SKILLING, HELLE, CHRISTIANSEN, ROBERTSON — Structural & Civil Engineers

PROJECT: THE WORLD TRADE CENTER | TITLE: DETAIL FOR SHEAR HEAD REPAIR K31/5 | DATE: 12-23-71

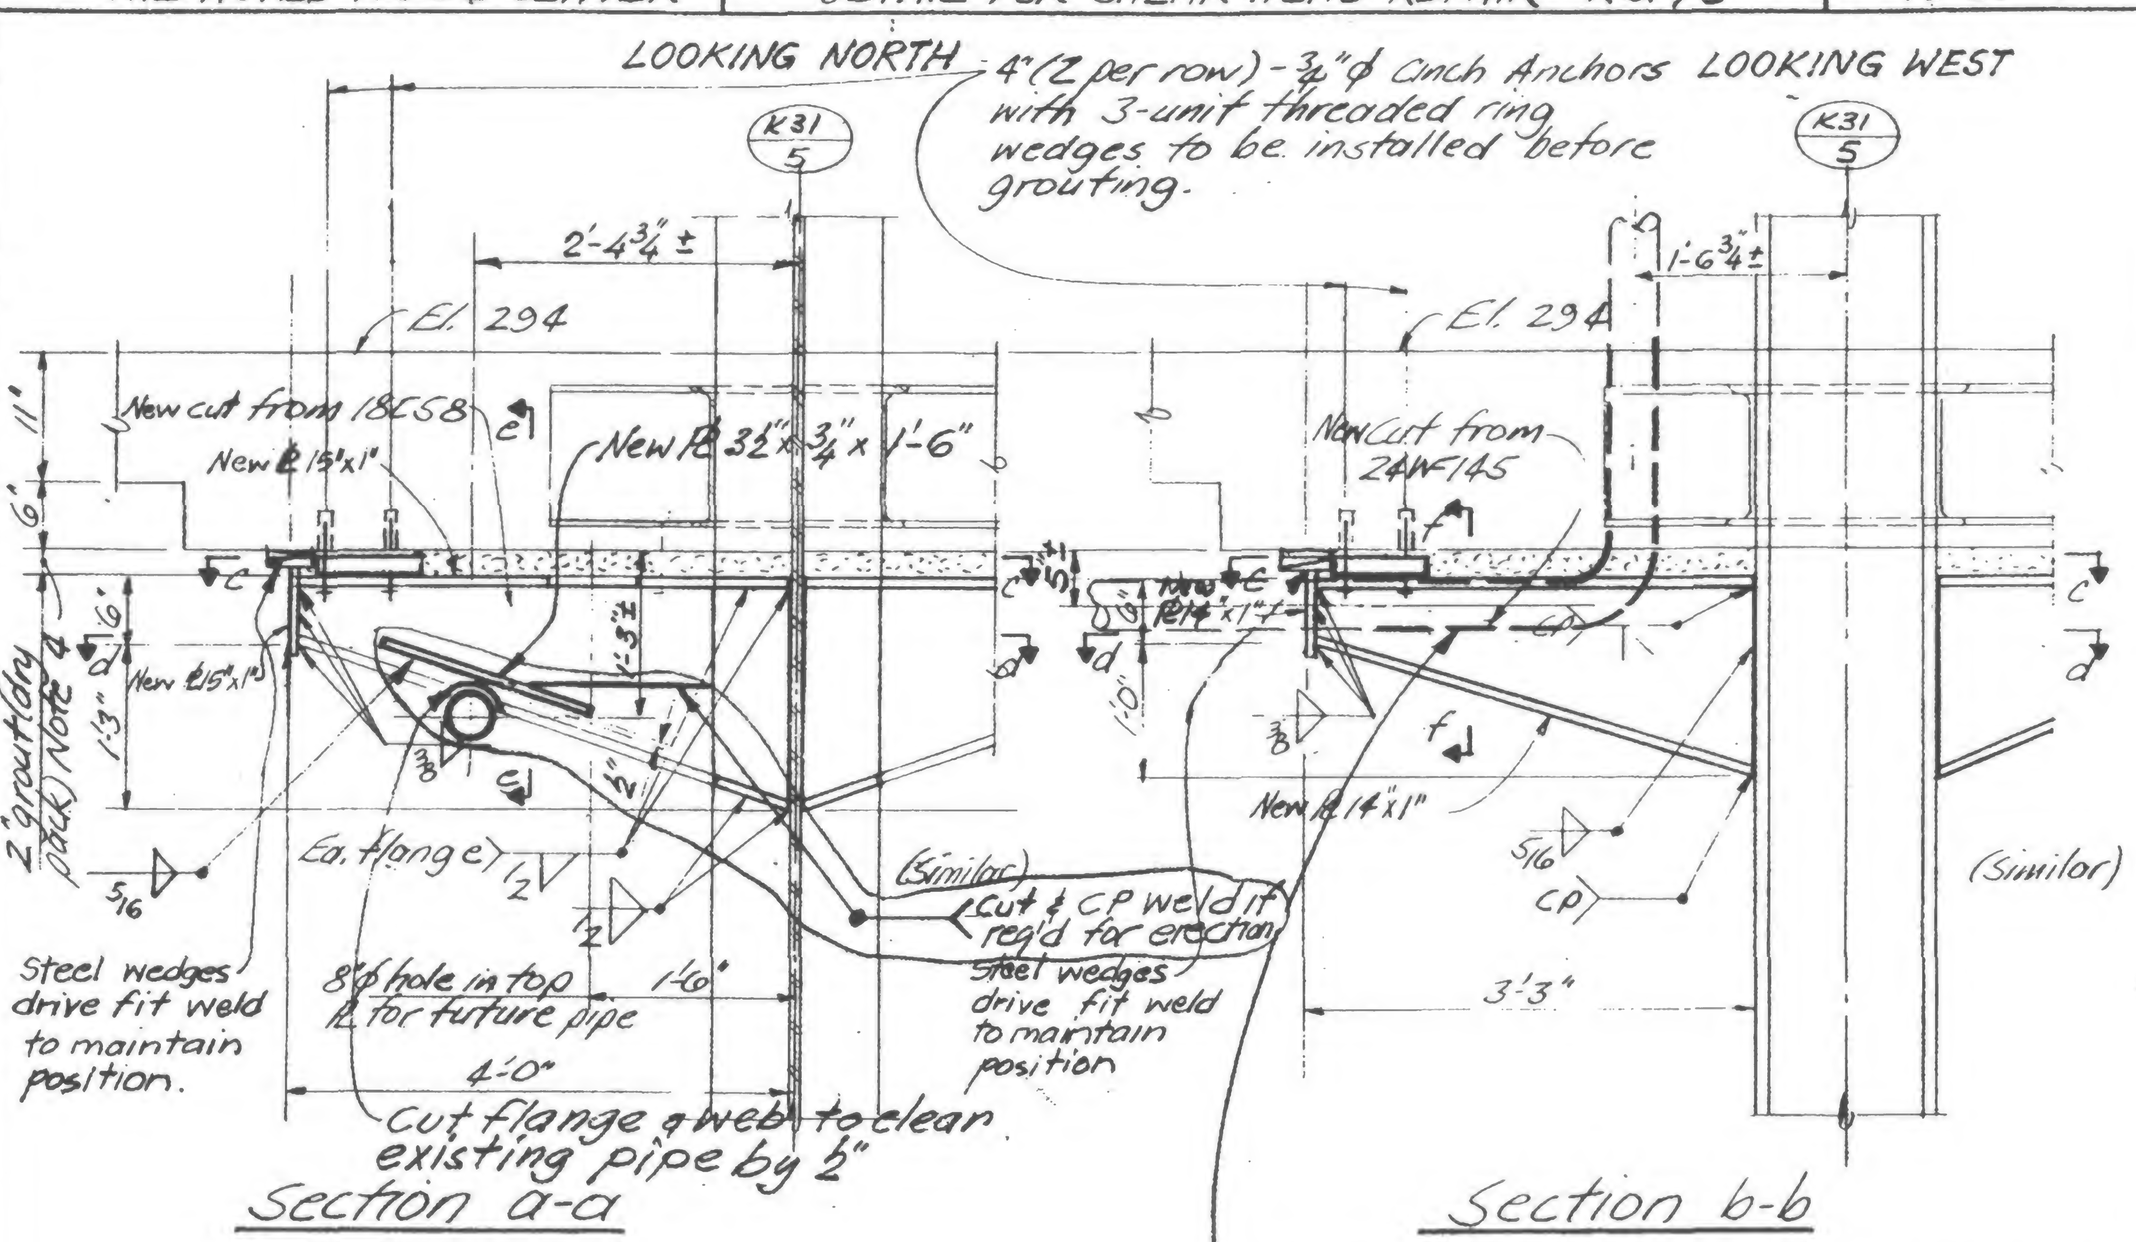
Remove existing pipe to clear new shear head. Pipe located in different position will be shown in future central service Drawings
